Access Compliance Report Public Rights-of-Way (Curb Ramps)

Main Street: LANESBORO_RD		Cross Street: STERLING_GLEN		Location:	SW
ADA ID: RPAT211101134821	Ramp Type: Type 4 - Parallel	Initial Pass/Fail: Fail	Overall Compliance: No	Severity Score:	15
Codes/Mitigation Info/Possible Solution			Field Measurements/Component Compliance

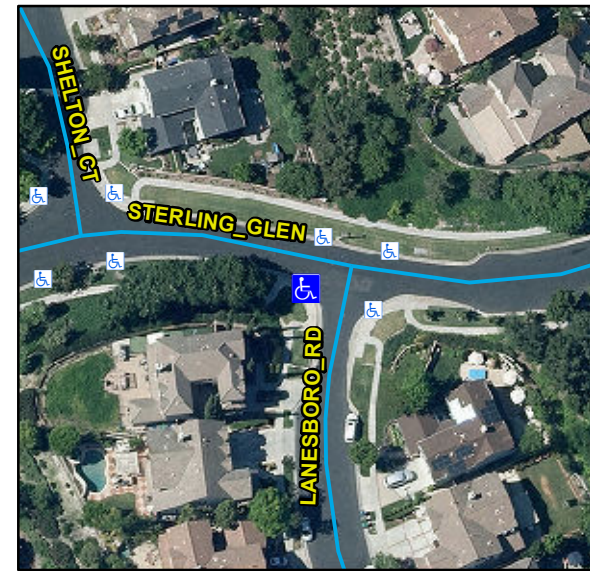
Compliance	Description	Data	Compliance	Description	Data
N/A	Ramp Length LT (in)	115	N/A	Ramp Length RT (in)	95
Yes	Ramp Width LT (in)	53	Yes	Ramp Width RT (in)	53
No	Ramp Run Slope LT (%)	12	Yes	Ramp Run Slope RT (%)	4.5
Yes	Ramp Cross Slope LT (%)	0.2	Yes	Ramp Cross Slope RT (%)	1.8
N/A	Landing Present	N/A	N/A	DWS Provided	N/A
N/A	Landing Length (in)	N/A	N/A	DWS Contrast	N/A
N/A	Landing Width (in)	N/A	N/A	DWS Length (in)	N/A
N/A	Landing Run Slope (%)	N/A	N/A	DWS Full Width	N/A
N/A	Landing Cross Slope (%)	N/A		DWS Offset Type	N/A
N/A	Landing Movement Obstructed?	N/A	N/A	DWS Offset Left (in)	N/A
	Landing Movement Type	N/A	N/A	DWS Offset Right (in)	N/A
N/A	Landing Shared	N/A			
N/A	Clear Space	Yes			
N/A	Clear Space To Crosswalk (in)	N/A			
N/A	Marked Crosswalk 1	No	N/A	Marked Crosswalk 2	No
	Crossing 1 Direction	SE		Crossing 2 Direction	NE
	Marked Crosswalk 1 Width (in)	N/A		Marked Crosswalk 2 Width (in)	N/A

Remove & Replace Curb Ramp With Two New Directional Ramps or Equivalent.
